Architectural Commission Report

Subject: **UMBERTO**

8840 Olympic Boulevard

Request for approval of a façade remodel and business identification signage. The Commission will also consider adoption of a Categorical Exemption, pursuant to the California Environmental Quality Act. (PL1329977)

OLYMPIC BOULEVARD FRONT FACADE RENDERING

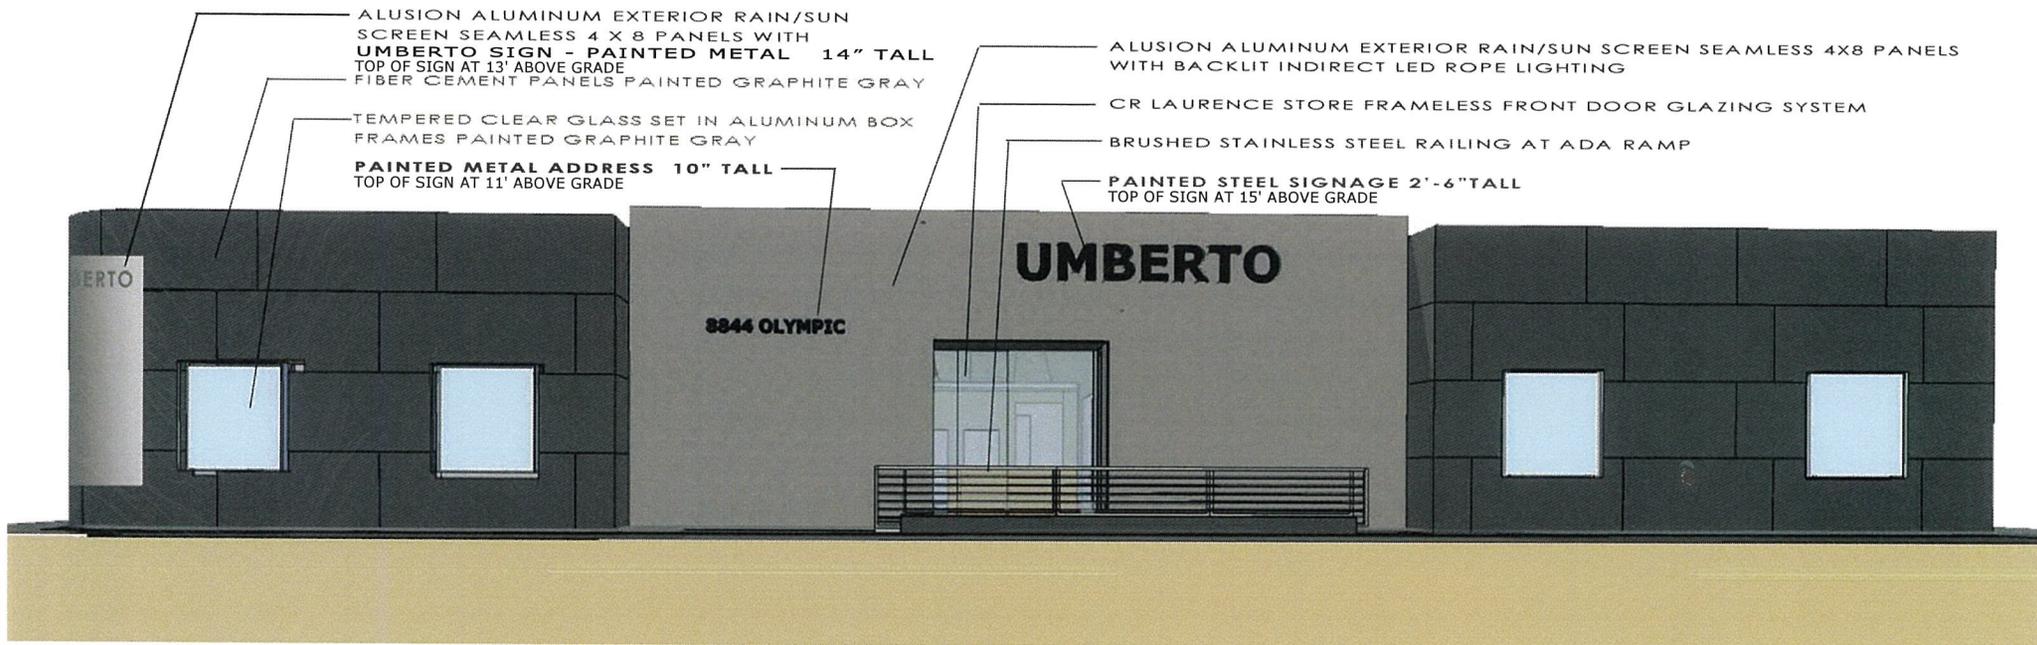
Based on the Urban Designer's review of the proposed project, the design of the proposed façade remodel is of good architecture and enhances the streetscape along Olympic Boulevard. It has been requested of the applicant to provide exterior lighting details and a night rendering, if possible, to further understand the designs impacts on the streetscape.

While the façade aesthetic is appropriate to the streetscape, the primary business identification sign on Olympic Boulevard is overly large for the building and should be reduced to a more appropriate size. Project-specific conditions have not been proposed at this time to address the issue though the Commission may wish to incorporate such conditions based on their review and discussion of the project.
